UNITED STATES ENVIRONMENTAL PROTECTION AGENCY

Re: BP America Production Company
Florida River Compression Facility
Title V Permit – Renewal #1
V-SU-0022-05.00

**Enclosure - Response to Comments on the Florida River Compression Facility's
March 28, 2008 Draft Title V Permit to Operate**

BP America Production Company
Florida River Compression Facility
Basic System Flow Diagram

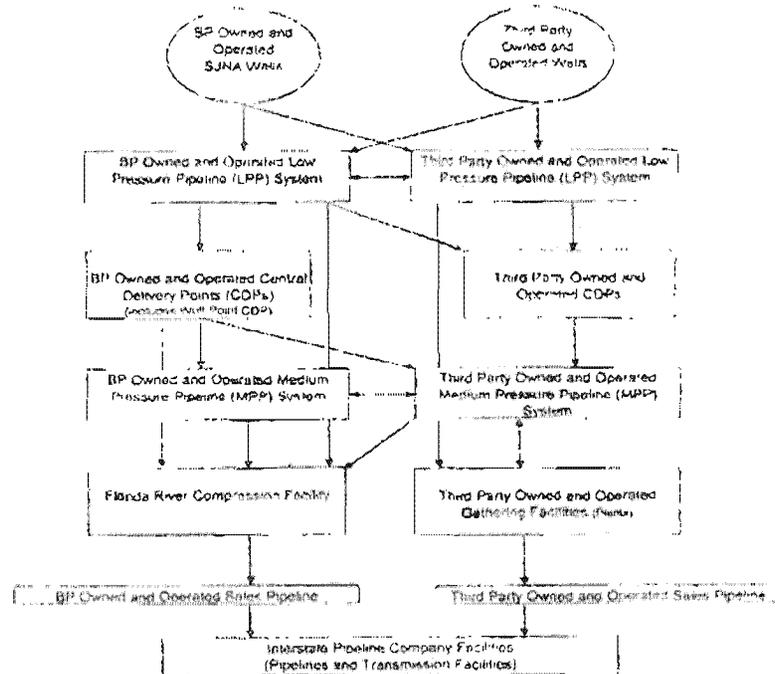
“BP gas” is transferred to third parties or vice versa, the gatherer takes custody of and assumes liability for the gas while in the gatherer’s possession, the gas is measured by the gatherer, and the shipper verifies those volumes with its own check meter.²⁸ The following process flow diagram illustrating the flow of gas in the field demonstrates the lack of a unique connection between BP facilities.²⁹
